UPDATE Technical Bulletin

72 12 01 July 10 2012 2029919

UPDATE – 72D8 Seat Linkage Bolts

Production Solution

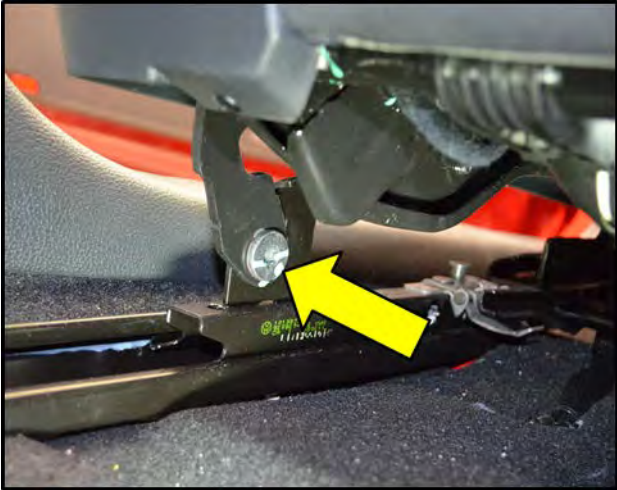
Tolerances between seat bolt (link screw) and seat bolt frame link pivot points may create squeaking noises while driving or while seat is being raised and lowered.

Install newly designed seat bolt (link screw).

<p>Section A – Replace Link Bolts</p> <p>Note: Driver seat shown. Perform procedure on both front seats (if applicable) based on chart below:</p>

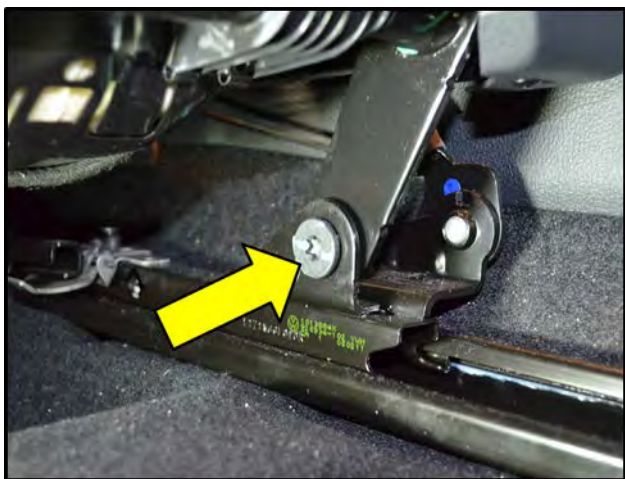
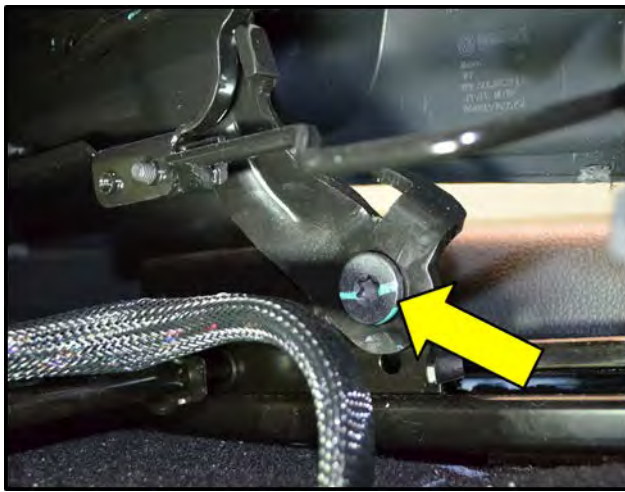
<p>Tip: To make repair easier, perform procedure on one bolt at a time.</p> <ul style="list-style-type: none"> • Move front seat forward. ⇐ Adjust seat height so that the seat bolt (link screw) <arrow> is accessible. ⇐ On left rear of seat frame, remove screw <arrow> using T-50 torx. • In same location, install new screw and washer from parts kit (5C6 898 515) first by hand, then tighten with ratchet equipped with T50 torx bit. ⇐ Torque screw <arrow> to 26 Nm. 	Criteria	Repair	01 & 02	Both front seats	03	Driver seat only
Criteria	Repair						
01 & 02	Both front seats						
03	Driver seat only

<ul style="list-style-type: none">⇐ On right rear of seat frame, remove screw <arrow> using T-50 torx.• In same location, install new screw and washer from parts kit (5C6 898 515) first by hand, then tighten with ratchet equipped with T50 torx bit.⇐ Torque screw <arrow> to 26 Nm.
	<ul style="list-style-type: none">• Move seat rearward so that the link screw <arrow> is accessible.⇐ On left front of seat frame, remove screw <arrow> using T-50 torx.• In same location, install new screw and washer from parts kit (5C6 898 515) first by hand, then tighten with ratchet equipped with T50 torx bit.⇐ Torque screw <arrow> to 26 Nm.• Vehicles with criteria 01 and 02, Move to opposite front seat and perform all steps above.• Vehicles with criteria 03 WORK COMPLETE <p>WORK COMPLETE</p>
